Re: Turkey Point Units 3 and 4
Docket Nos. 50-250 and 50-251
Revised ECCS Analysis

This evaluation supports several changes to the Technical Specifications which have been brought about by the potential plugging of additional steam generator tubes at Turkey Point Units 3 and 4. Technical Specification 3.1.6.c (Reactor Coolant Flow) and 3.2.6.a (Hot Channel Factors), the Over-temperature ΔT and Overpower ΔT equations, and Figure 2.1-1 (Reactor Core Thermal and Hydraulic Safety Limits, Three Loop Operation) will be affected.

TO	R. E. Uhrig	LOCATION	Miami, Florida
		DATE	January 26, 1978
FROM	A. D. Schmidt	COPIES TO	J. R. Bensen/C. O. Woody
			G. E. Liebler/932.1 TP
SUBJECT:	TURKEY POINT UNITS 3 & 4		H. E. Yaeger/J. K. Hays
	PROPOSED TECH SPEC CHANGE		R. J. Acosta
	<u>ECCS REANALYSIS (19% S/G PLUGGING)</u>		N. F. Ajluni
			G. D. Whittier
			PRN-LI-78-20

REACTIVITY INSERTION RATE vs. BORON CONCENTRATION
TURKEY POINT UNITS 3 & 4

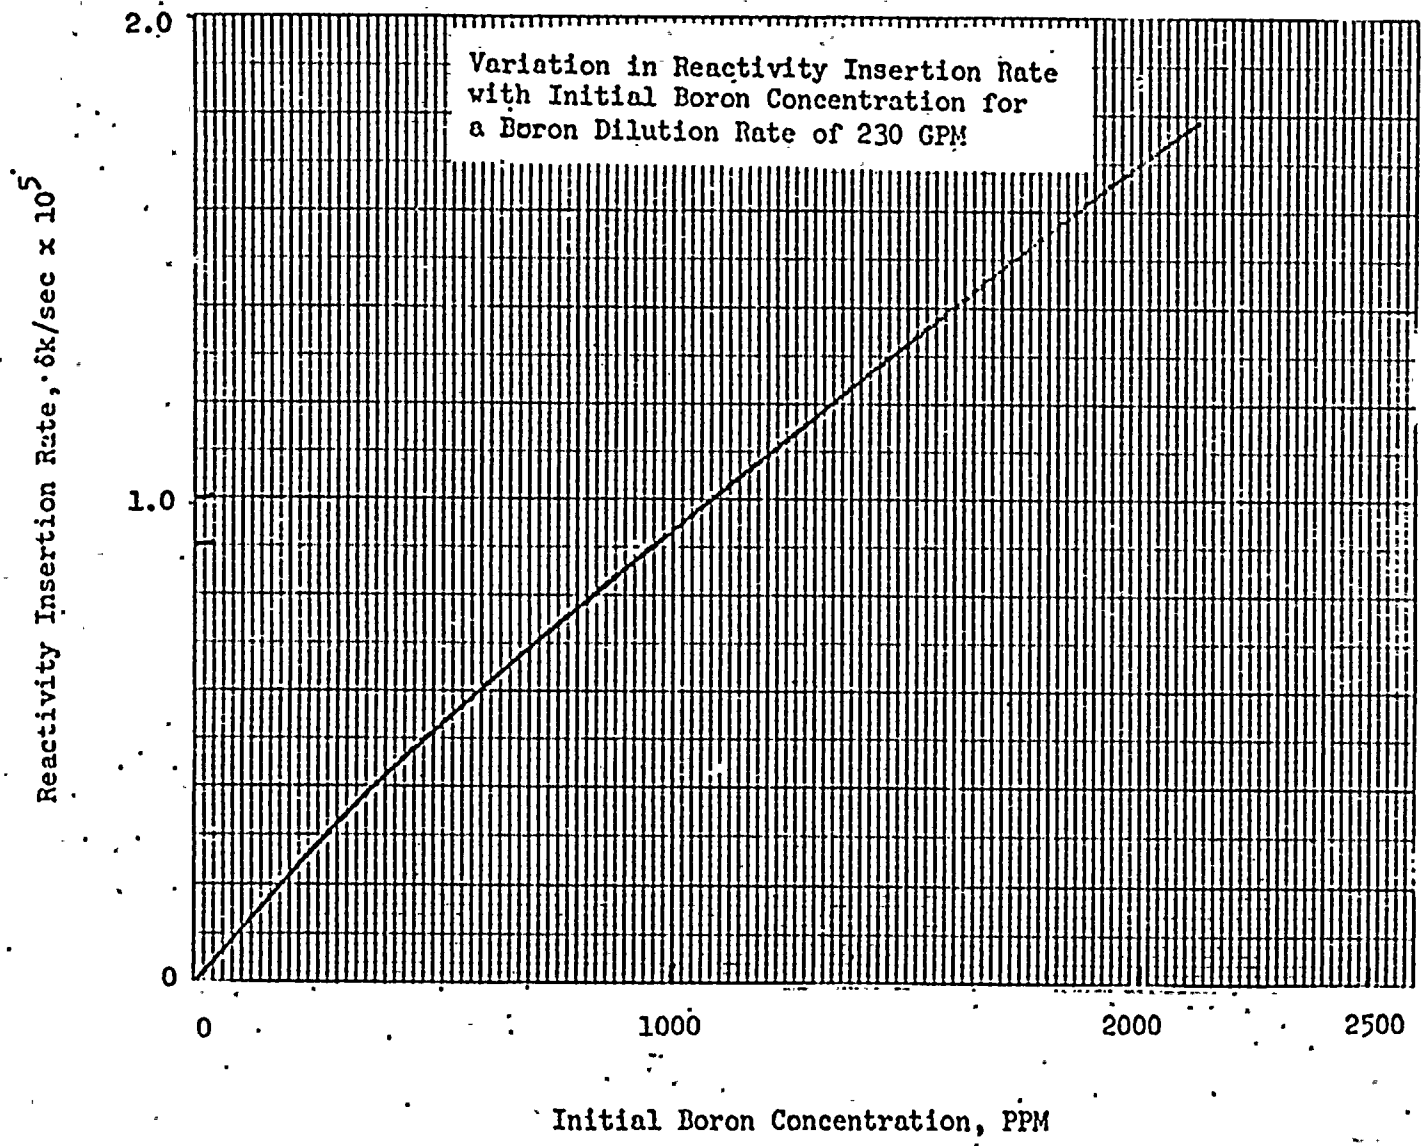
For dilutions during power operation a highly conservative reactivity insertion rate of $1.1 \times 10^{-5} \delta k/\text{sec}$ was assumed in the FSAR consistent with an initial boron concentration of 1200 ppm. FSAR figure 14.1.5-1 (Reactivity Insertion Rate vs Boron Concentration) has been recalculated consistent with the lower primary value and is attached. The results show that the reactivity insertion rate assumed in the FSAR is still conservative. Therefore no additional analysis is required. It should be noted, however, that the FSAR analysis is still highly conservative with respect to the current cycles since the analysis assumed that only 1% shutdown margin is available. The Turkey Point Units have been designed such that > 2.5% shutdown margin is always available for BOL conditions. The result is that operator action times would be > 70 minutes with the more realistic value.
